Planning Application 240173: Broad Street Mall (BSM), Reading, RG1 7QG

Comments by: Baker Street Area Neighbourhood Association (BSANA)

Figure 1: View of the proposed development from the corner of Jesse Terrace and Baker Street (credit: Environment Impact Assessment)

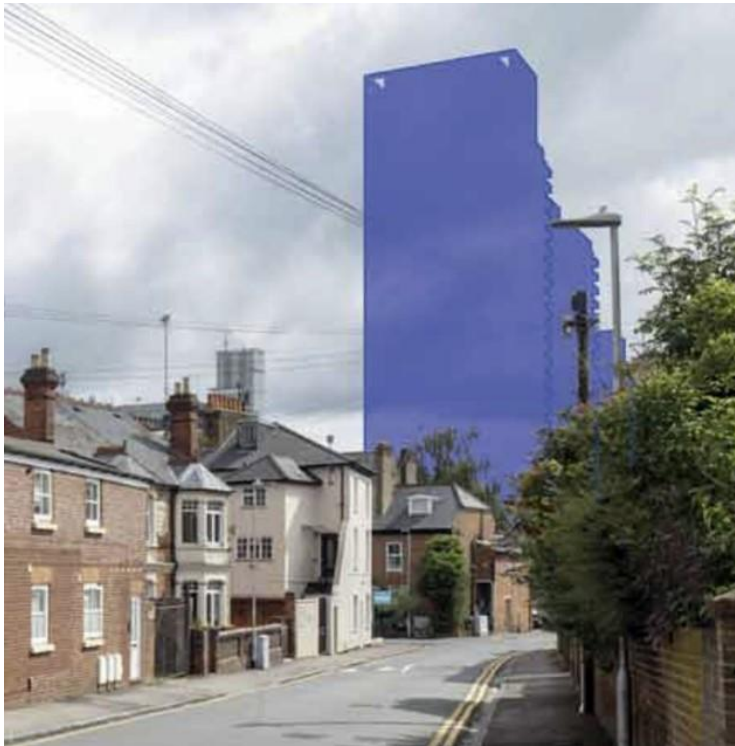
- 6.1.1 Figure 1 in the introduction is taken from the EIA of the application, the view is from within CHRSORCA, BSANA's Conservation Area. The image has produced a shocked reaction from BSANA's residents as it clearly shows the considerable visual damage caused by placing a very large 30-storey building next to a low rise conservation area.

Figure 3: Minster Quarter Area Development Framework Boundary and Ownership. Image from MQADF.

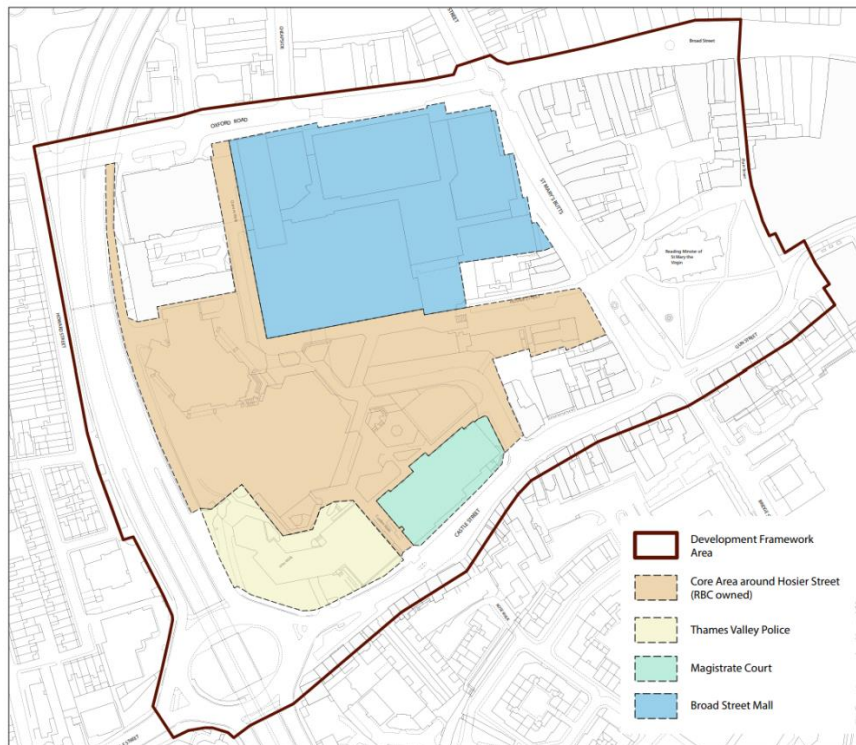
- 1.3 The BSM development site represents a significant share of the development area referred to as the Minster Quarter Area (MQA), also included within the MQA is the old civic centre site, the police station (who are currently relocating from this site) and Reading Magistrates' Court and Family Court (who have not declared an intention to relocate).
- 1.4 Due to the historic importance of the area surrounding the MQA, the challenging development site and the need for a coherent design and implementation strategy from the different owners, the Minster Quarter Area Development Framework (MQADF) was produced by RBC.
- 1.5 The boundaries of the MQADF are given in figure 3 below.

Figure 8: MQADF - BSM maximum permitted development height and grading down.

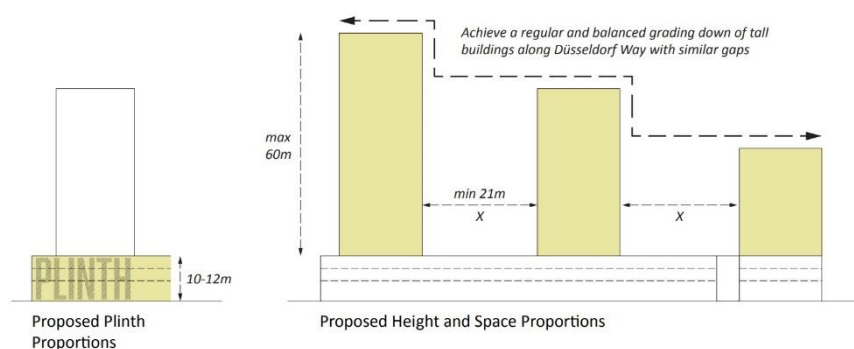
- 2.3.1 The MQADF sets out specific development parameters for the BSM site, restricting towers within the MQA to a maximum of 20 storeys and a maximum height of 60m (20 storeys at 3m each). An exception was given to BSM in that it was expected that the towers would sit upon the existing structure, so the storeys would be counted from the top of the BSM rather than street level. The MQADF adds a further condition that the towers should reduce proportionally in height from site A to site C i.e. towards Reading Minster, from 20 storeys to an implied 10 storeys above BSM, with site B being 15 storeys above BSM.

- 2.3.2 The MQADF states ***“A threshold of 20 storeys above podium is considered the maximum permissible height for tall buildings generally within the site and this should be considered as a maximum to which other buildings step up to.”*** ***“Slender building forms are encouraged, for reasons of overall skyline appeal, reduction of overshadowing and improvements to distances between blocks.”***

Figure 11: The areas in pink above the towers have been added by BSANA to show how much the applicant exceeds the MQADF permitted heights of the towers (the images do not show the increase in mass of the towers). Aerial view above Baker Street. Image taken from MQADF and modified by BSANA.

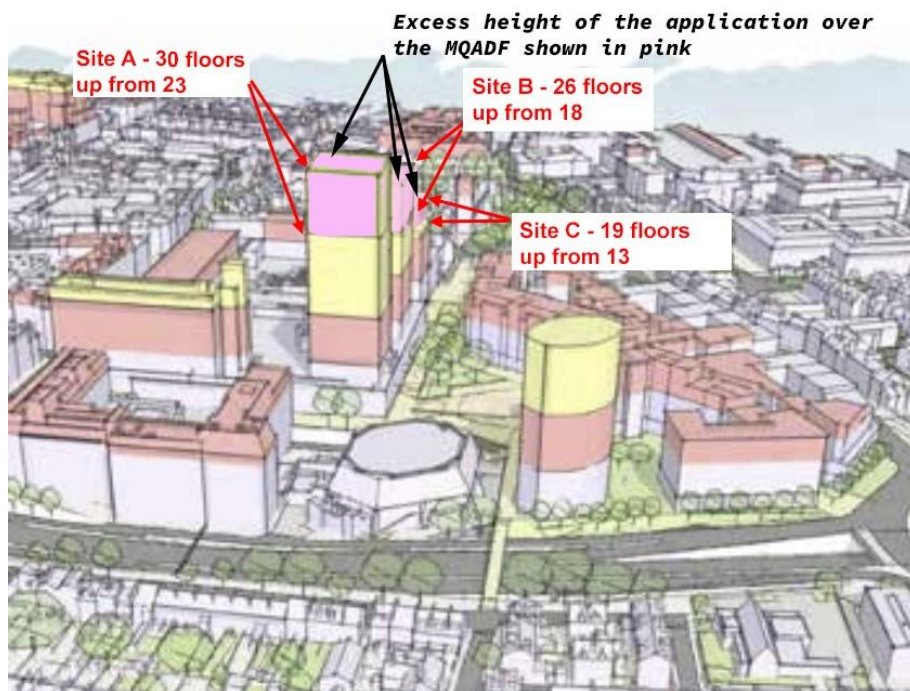
2.4.4 The impact on the aerial view of the additional storeys is clearly demonstrated in figure 11.

Figure 14: The MQADF goal was to minimise the visual impact of the towers from the front of Grade I listed Reading Minster

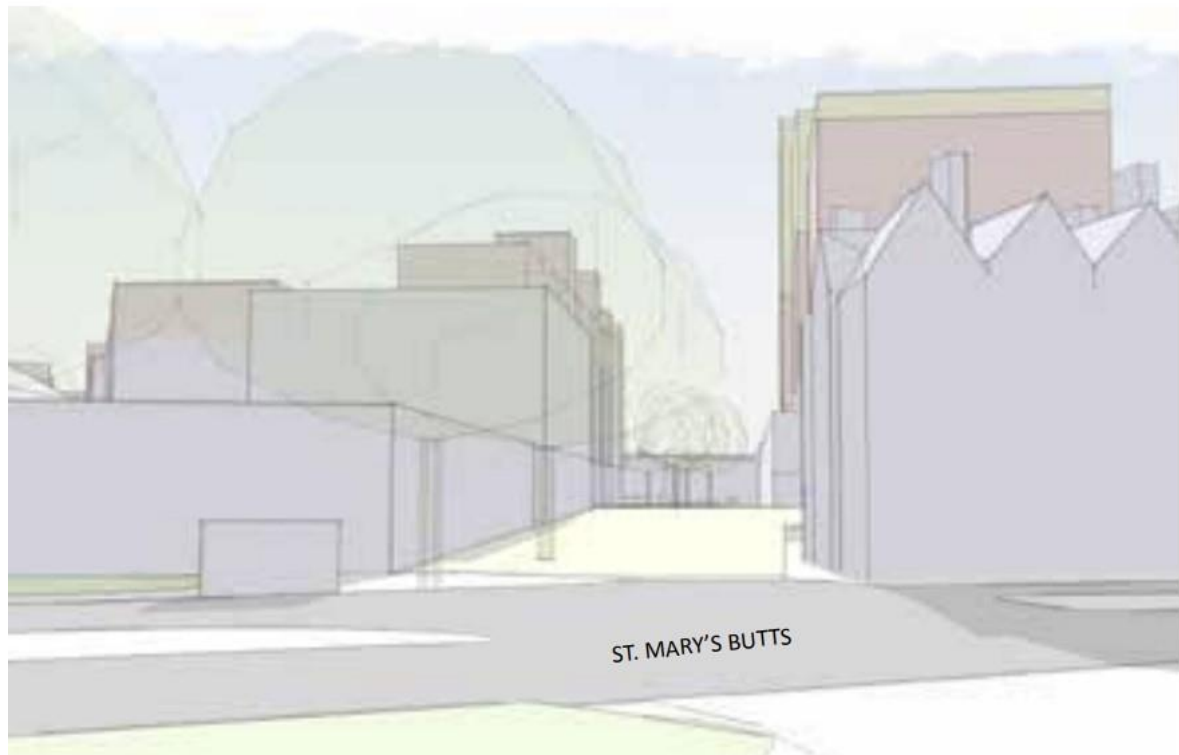
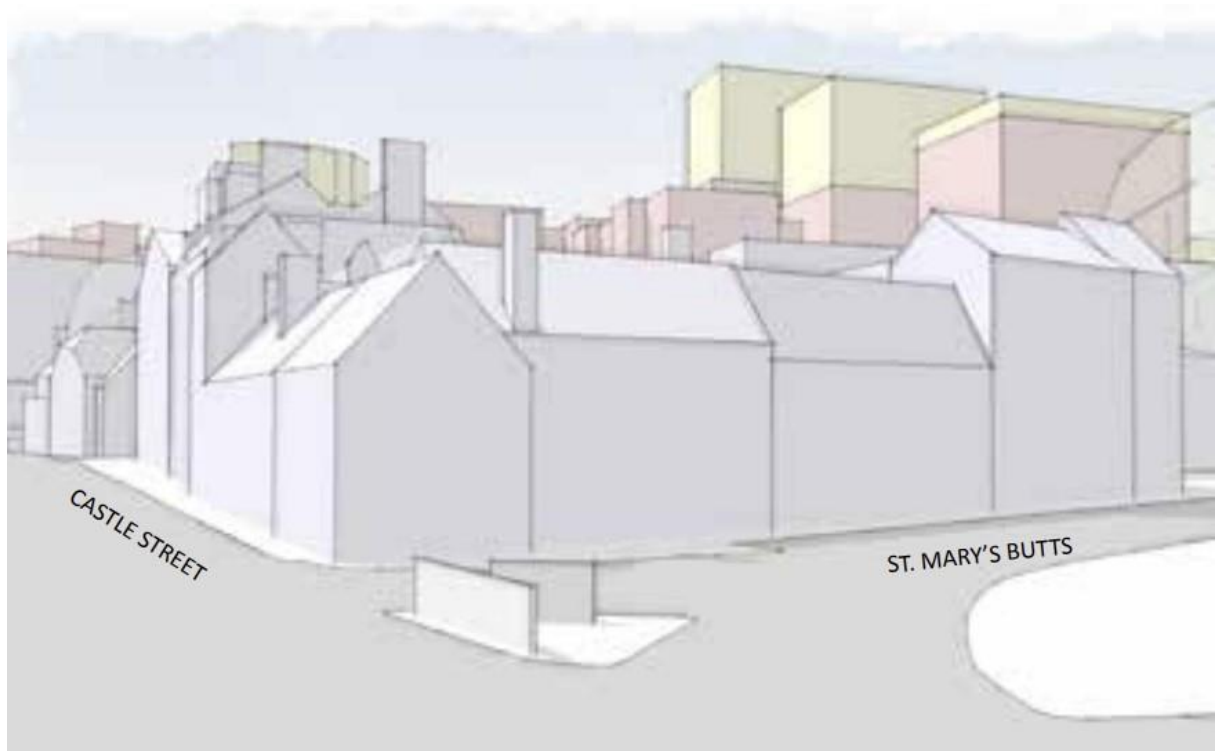
- 2.4.8 Figures 14 to 18 show significant visual harm caused by the proposed towers when viewed from within the SMBSCSA and the effect of the addition of between 6 to 8 storeys to the tower blocks, over the MQADF development parameters. If 7, 8 and 6 storeys are removed from towers A, B and C respectively and there is a reduction of their footprints then the impact of the towers would be significantly reduced (adhering to the MQADF).

Figure 20: Proximity of open space and play areas from the development site, highlighting very limited seating of nearby greenspace – image from the application modified by BSANA

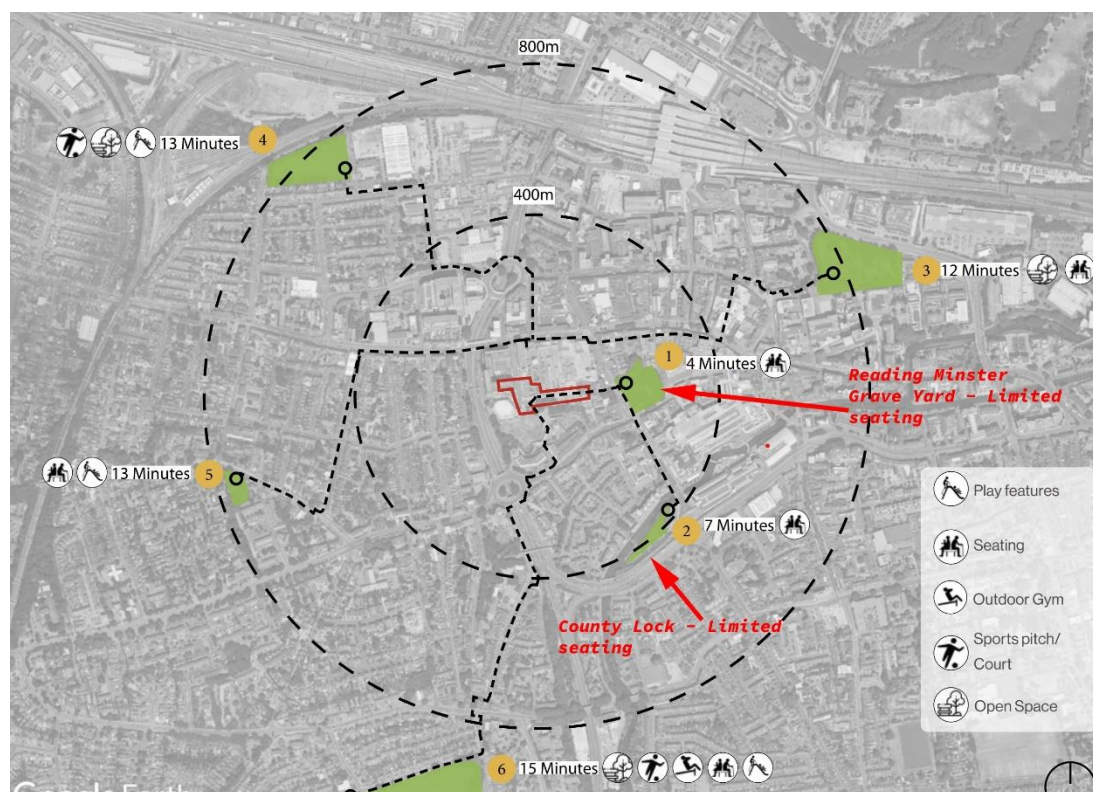
3.2 Figure 20 below highlights that the closest public play areas are approximately 1 kilometre walk away from the development site. Play areas are accessed by crossing busy roads. The proposal highlights Reading Minster's grave yard and County Lock as seating areas, but there is currently only a single bench in each location, this compares to the 644 dwellings of the development site.

Figure 22: Internal space at roof level 27

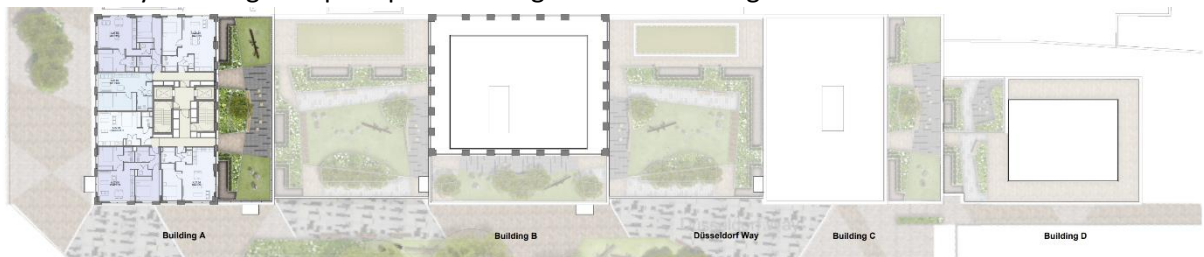
- 3.6 Figure 22 above shows internal space at level 27 of site A. Internal open space is provided 2 to 3 floors below roof level for each of the towers (at levels 27, 24 and 17 for towers A, B and C respectively). Given how exposed these open spaces at their respective heights then their suitability for use will be restricted to windless days.
